Plan Review Comments Response

MacKay-Lyons Sweetapple
Architects Limited

Date: 2016.11.16

Project No: Summit Powder Mountain Bldg. 4
Footings & Foundation Only

SHEET NUMBER
1.02

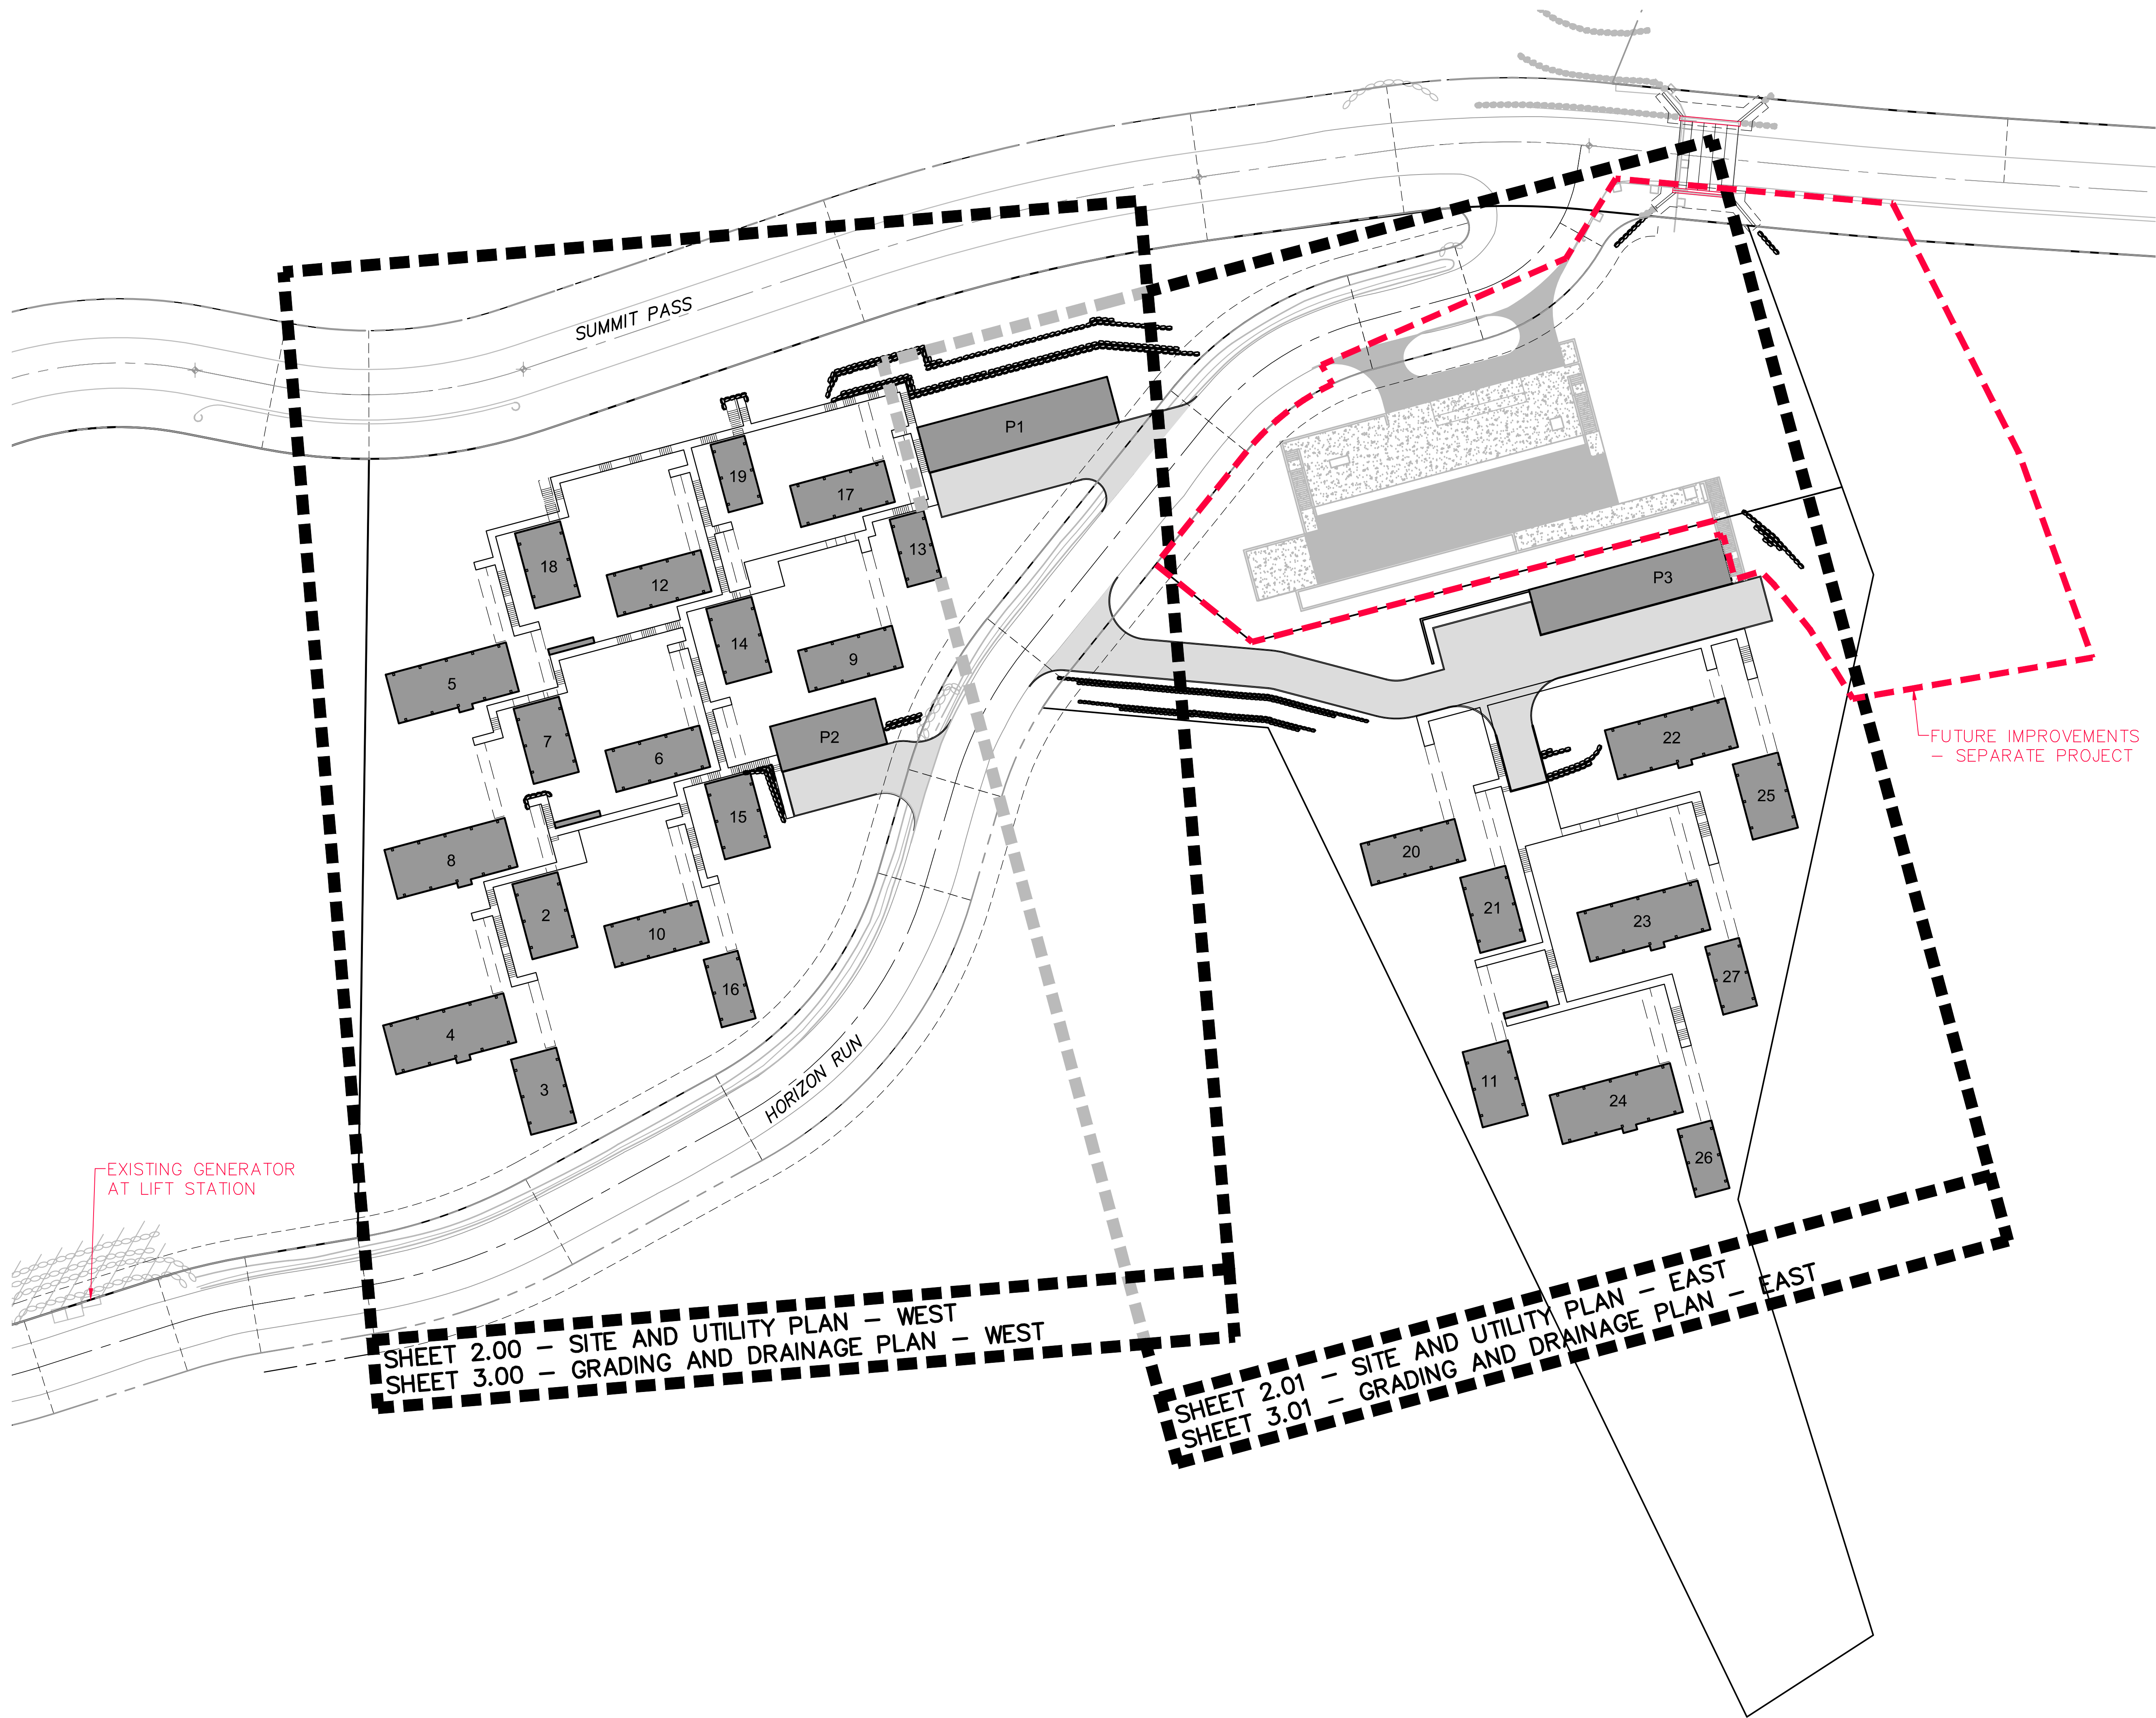
- A2. *Sheet 1.02: Please address the following:*

- A. *Please clearly identify the Building or Buildings to be built under this permit, as this sheet does not make it clear. Identify with bold line work, hatching or leader arrows the specific building associated with this permit. Otherwise it is assumed this permit is for a single building (Bldg. 4) as indicated in the permit application.*

This permit is for a single building (Bldg. 4). Please see supplemental civil drawings specific to Buildings 3 and 4.

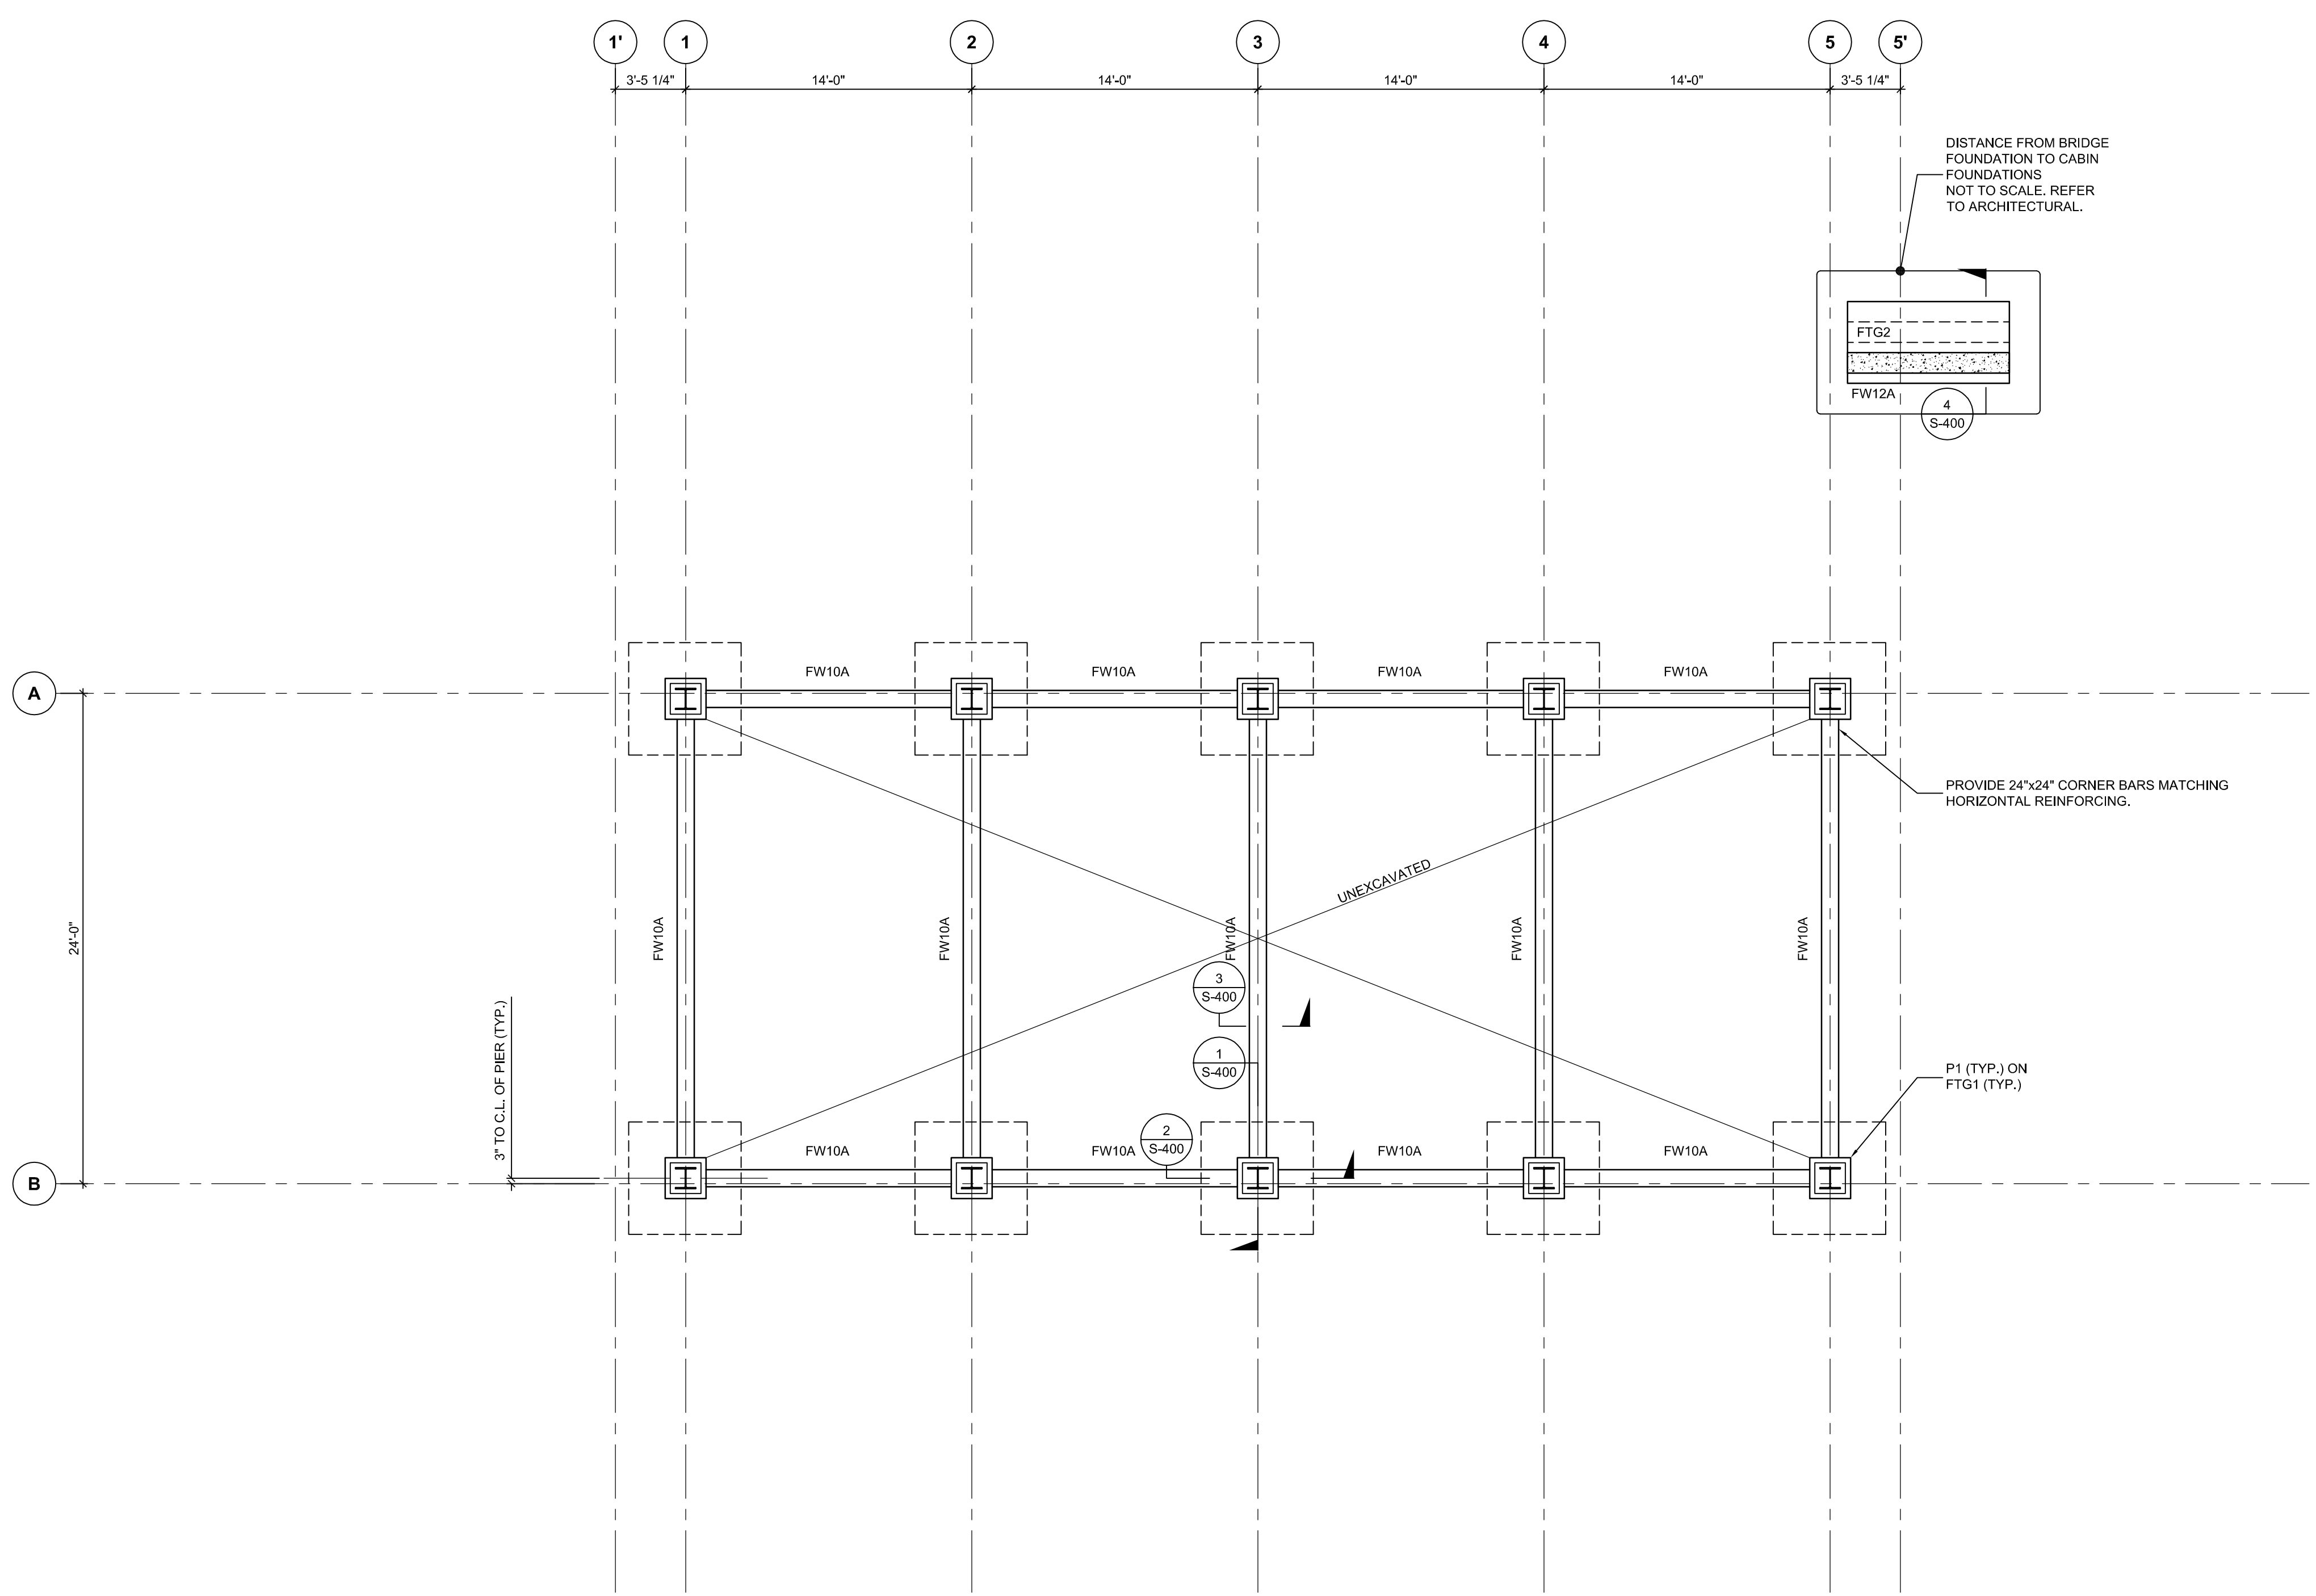
S5. Sheet S-100: Footing FTG1 does not meet the minimum reinforcement requirements of Section 24.4.3 of ACI 318-14).

Please refer to the revised FTG1 on S-100.
